Ballard Pump Station

Meeting Summary

Schematic Design (60% design)

Figure 2: Updated design concept proposal (middle) and image of proposed art, sight lighting, and fencing material (bottom)

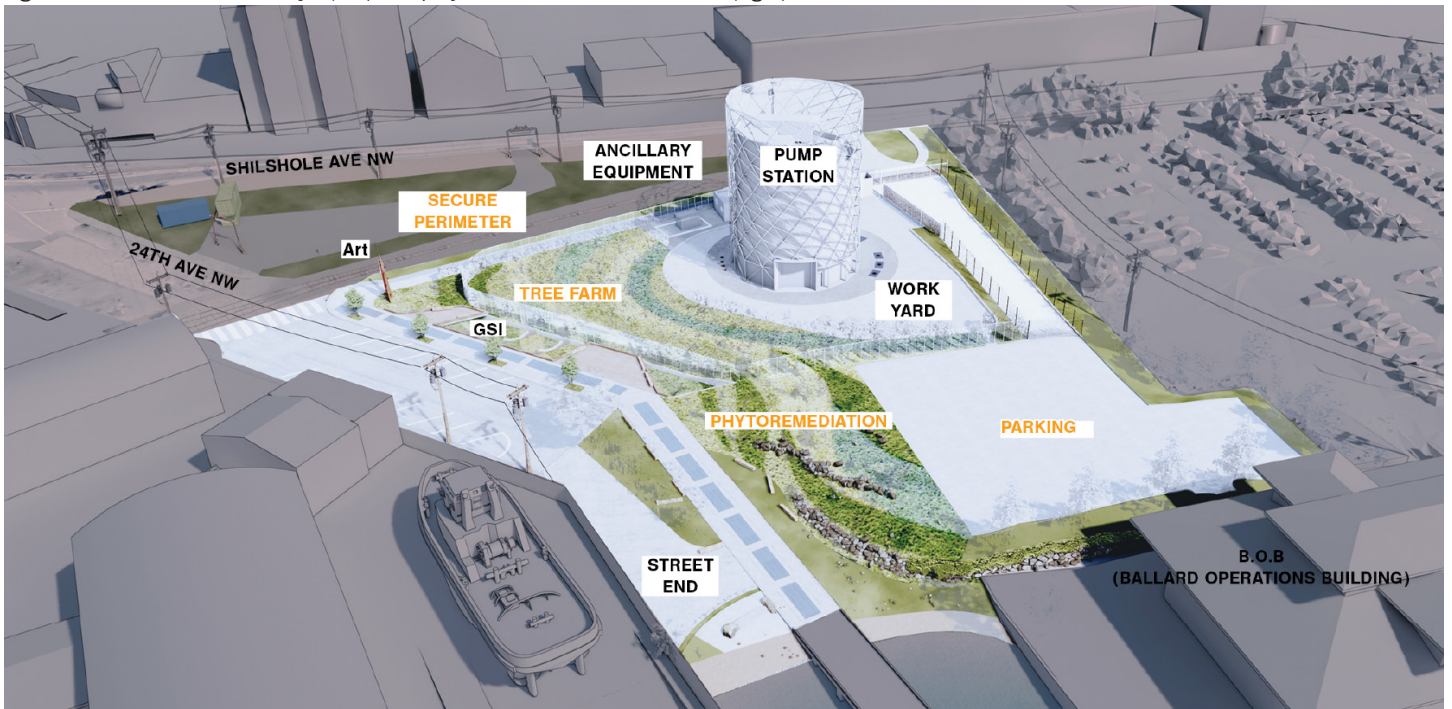
Commissioners cautioned the team about the proper placement, angling, and amount of lighting used for the tower, given the variety of materials and levels. Commissioners were encouraged to hear that the team would construct a mock up to better understand the ambient lighting, and advised the team to consider views from the pedestrian level, in three dimensions, and in conjunction with the lighting and materials choices for the fence/scrim.

Commissioners expressed understanding for the need to provide a fence at the pump station but wondered if it was truly necessary to protect the innovative temporary tree farm use. Commissioners encouraged the project team to consider changing the height, permeability, and location of the fence. The Commission discussed whether the fence could be designed differently to create less of a visual barrier. Understanding the challenges of the fence needing to be both a backdrop and protection, commissioners questioned whether the opacity of the scrim material of the fence could be changed to better relate to the sculpture and tower. Commissioners also stated that a visually permeable fence material might make the tree farm more visually accessible. The Commission then encouraged the project team to carefully select a fencing material that will not fade within the near future.

4. As you develop lighting mock ups consider ambient light, the multitiered and sided characteristic of the art, and the pedestrian perspective. Concern lighting might be too bright for the surroundings and could distract immensely from the art.

5. Consider relocating the fence eastward and/or lowering it to allow more public interaction (visible or physical) with the tree farm.
6. Consider a more permeable, transparent material for the fence.
